SEVENTH ADDENDUM TO INVITATION TO BID
FOR THE DURHAM WRRF PHASE 6B DIGESTER PROJECT NO. 7203

ISSUED: OCTOBER 29, 2025

PROJ NAME: CLEAN WATER SERVICES DURHAM WRRF
PHASE 6B DIGESTER

E DOWNSPOUT 2
725-A-331 NTS

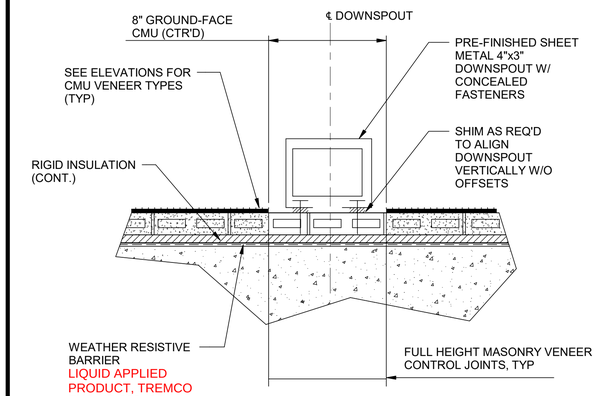
1. 725-A-331.

Clarified the weather resistive barrier product.

9. Question 9: Detail E on page 725-A-331 shows a weather resistive barrier behind the rigid insulation. This is the only detail that shows this condition. There is no spec section for weather resistive barrier. Can you clarify if the WRB will be required and if so, can a spec section be provided.

Answer 9: The weather-resistant barrier shall be a liquid-applied product, such as Tremco ExoAir 220, or equal. Refer to Drawing 725-A-331 included in Exhibit A of this Addendum.

HOSE RACKS

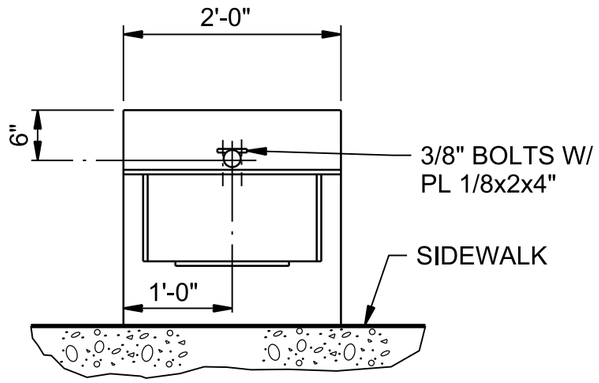
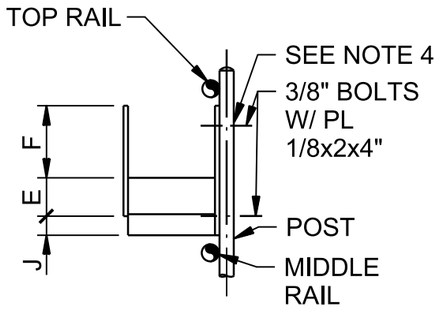
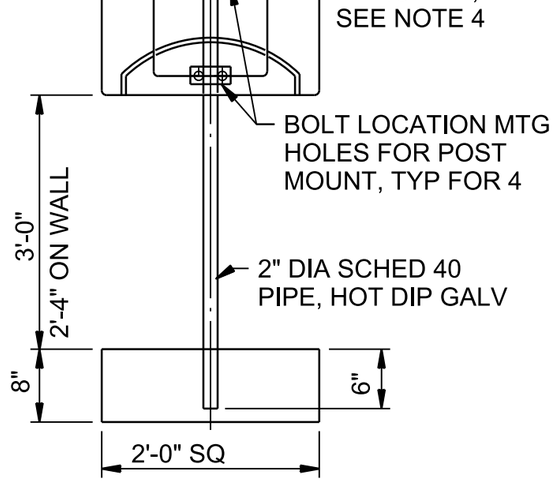
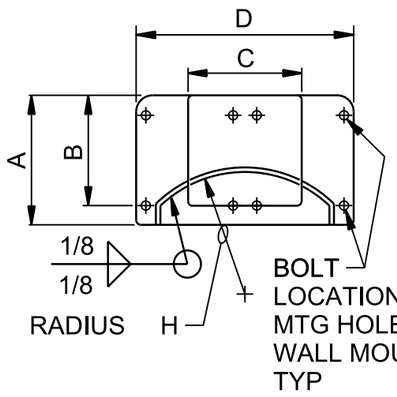
b. Add Standard Detail 15720 Hose Racks included in Exhibit B of this Addendum.

12. Question 12: On the Civil plans the Hose rack detail 15720 is what we are referred to, however once we look at the standard drawings provided this detail is missing, can it please be provided?

Answer 12: Detail 15720 is included in Exhibit B of this Addendum.
